SUBJECT: NEI International Nuclear Event Scale Recommendations July 2003

Nuclear Energy Institute
International Event Scale Meeting
June 25, 2003

PWR Typical Technical Specification Activity Example Curve

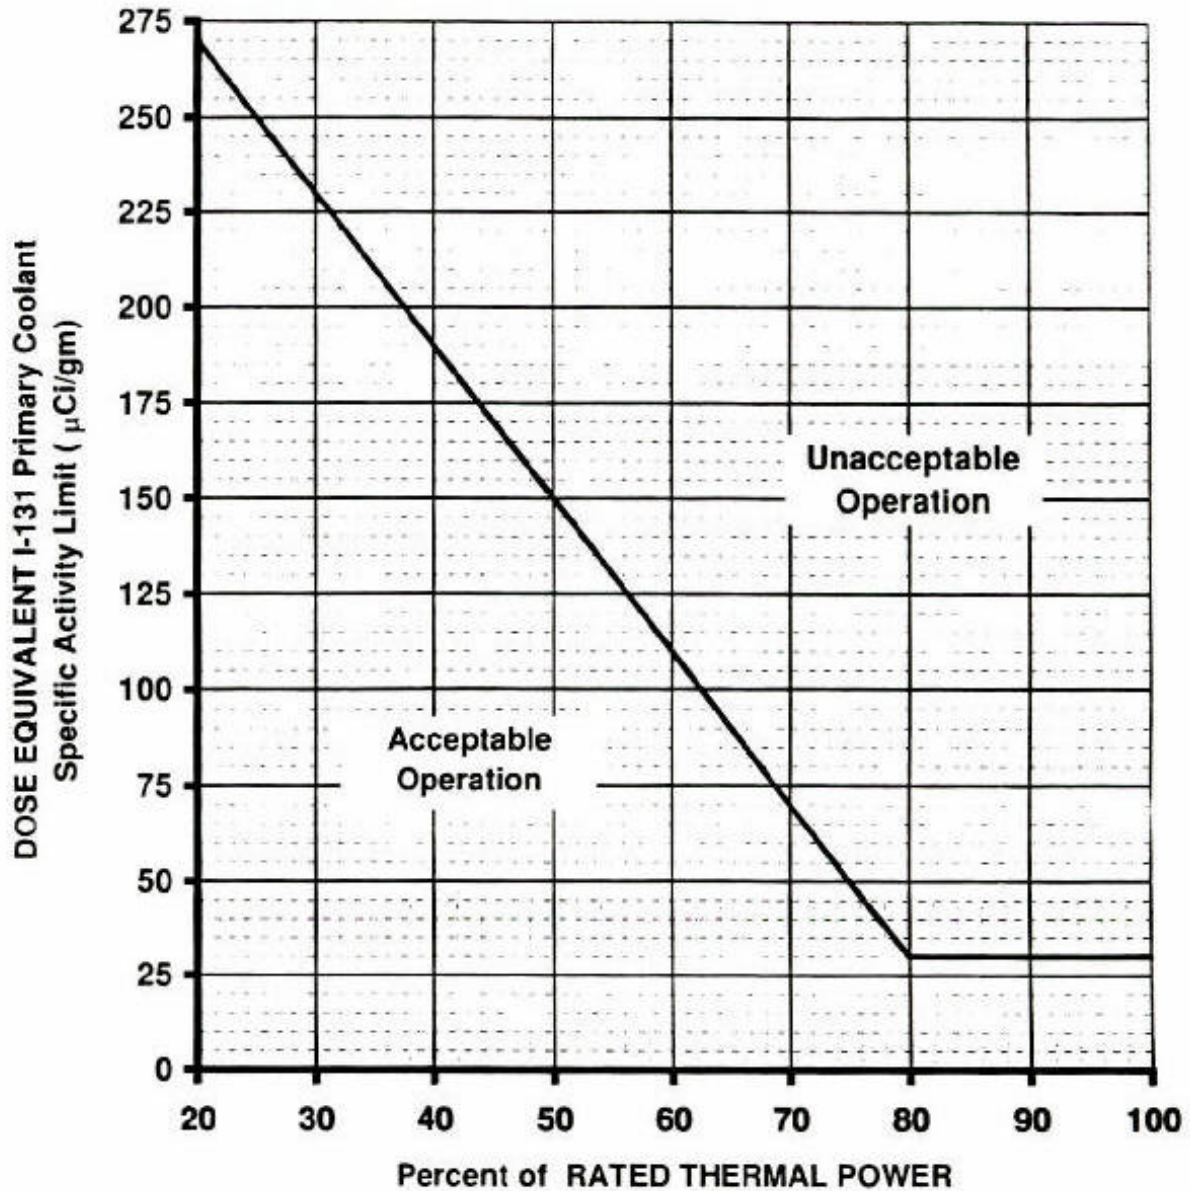
In most US industry events involving fuel clad damage over the last 20 years, RCS activity has remained within the Technical Specification LCO range with I-131 coolant activity remaining in the acceptable operating range of the Technical Specification activity limit curve (an example typical PWR curve is attached). Using a literal interpretation of the INES criteria these events could have been misinterpreted, especially for BWR events, and end up being over-classified using On-Site impact criteria instead of Defense-in-Depth impact criteria. The following supporting details assume that "barrier damage" or "core damage" is synonymous with "clad damage" (i.e., this is not an overheat/melt condition):

DEI elevated into the Unacceptable Operation region of the Technical Specification transient limit requiring shutdown.

DEI elevated into the Allowable Operation region of the Technical Specification transient limit for greater than the specified action statement time limit requiring shutdown.

DEI elevated out of normal Technical Specification operating limit but returned to within normal operating limit within specified action statement time limit with no shutdown required
